To: Menlo Park City Council

From: Gary Lauder

Re: Changing 101/Willow Rd. interchange from cloverleaf to partial cloverleaf

Date: Tuesday, February 23, 2016 [\[and updated subsequently\]](#)

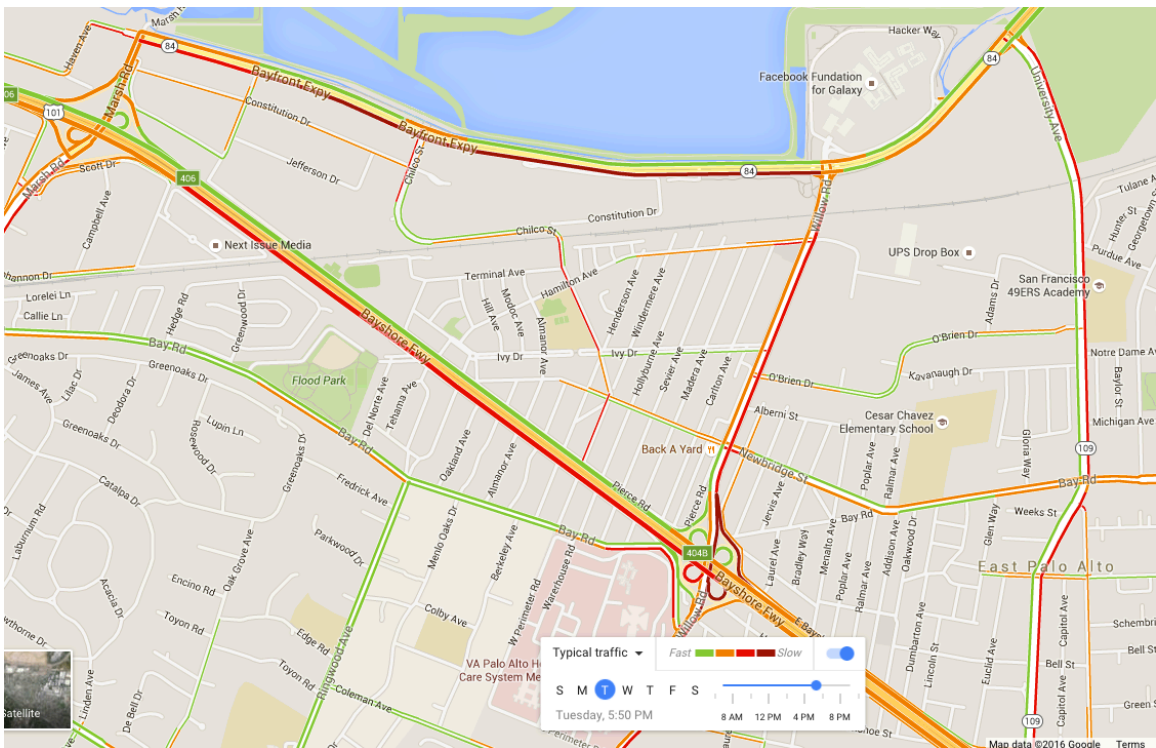
At present, it spills back a full mile. The present traffic queue already exceeds the projections made for 2020. If the exiting traffic destined for westbound Willow were to be added to the existing queue, it would extend the queue beyond the University entrance ramp (and perhaps also the exit ramp). This would create a new hazard of crossover traffic, which has not been publicly evaluated.

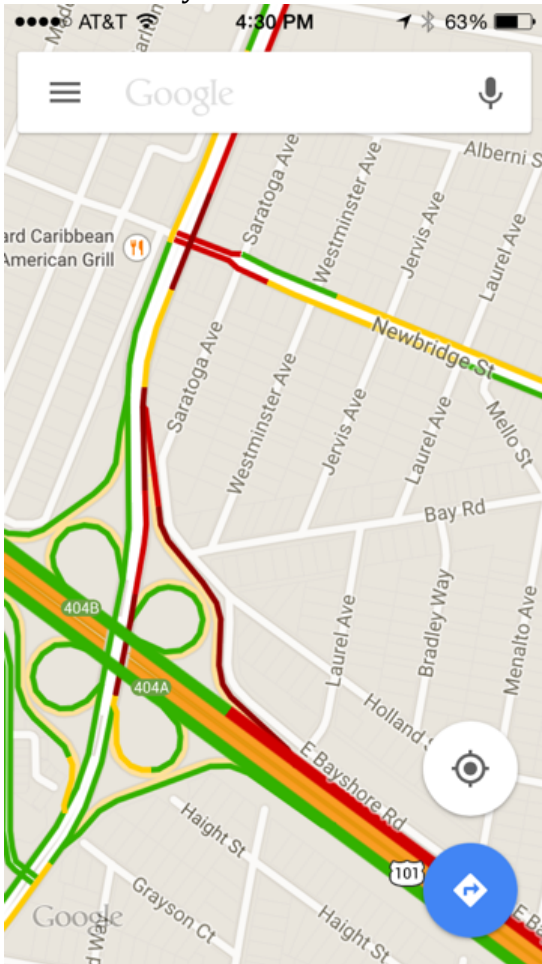
“The purpose of the project is to address the operational deficiencies of this interchange for all modes of travel and to reduce backups and upstream queuing on US 101. The need for this project is to reduce existing and expected traffic congestion in the vicinity of US 101 and Willow Road. **This congestion is being caused because of short weaving segments between loop ramps along US 101/Willow Road Interchange. These short weaving segments create weaving conflicts resulting in reduced traffic speed and increased upstream queuing and backups.**”

Anyone who drives this intersection knows that that is not the cause of congestion in this vicinity.

Diagrams added 5/24/16. From page 5 of: <http://www.menlopark.org/DocumentCenter/View/9771>
Current:

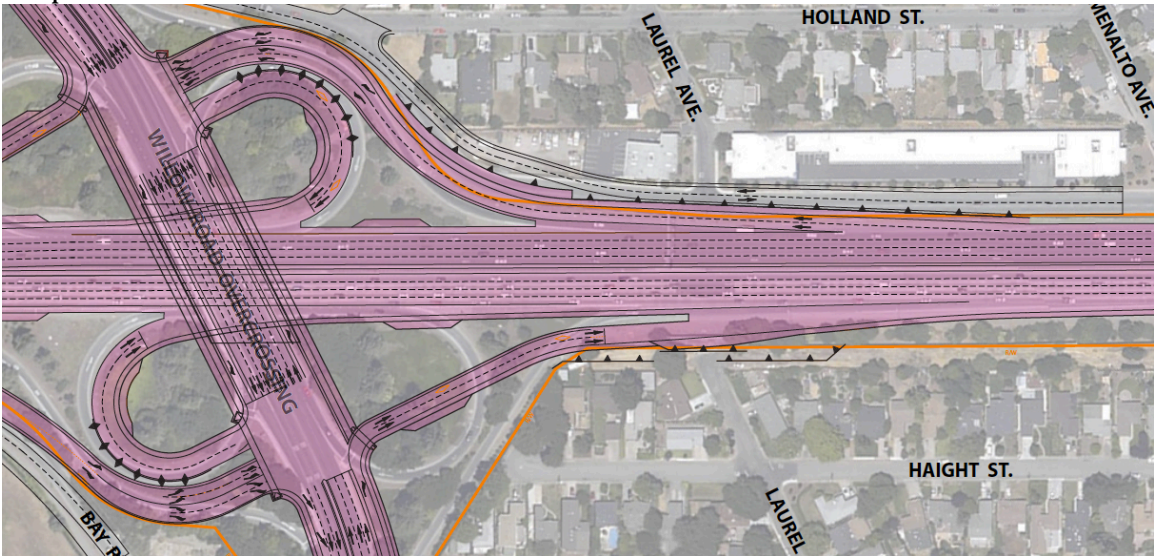
- 4) CalTrans claims that by having 2 right-turn lanes, it provides more "storage" for cars that are queuing that would reduce the backup to the highway. That might have been a valid claim back when the queue did not spill onto 101, but it's now a mile long. The planned incremental lane length looks to be <200', which is <4% of the maximum queue. The fact that officials still claim this shows that some form of delusion is occurring, either self-delusion or intentional. See close-up diagram extracted from larger diagram on next page:

Q: Do you really think that everyone headed east will stay in the right lane leaving the left lane clear for people turning left (west)? Q: Do you think that those who don't realize that the queue that starts a mile back at University Ave. and miss getting on the back of the queue will not attempt to exit at Willow and cut in (and therefore clog the west-bound exit lane)? Both questions can be answered by your trying the Marsh Rd. exit at the PM rush hour. Hint: the answers to both are "no." Below: zoomed in view of proposed northbound 101 exit lanes at Willow.
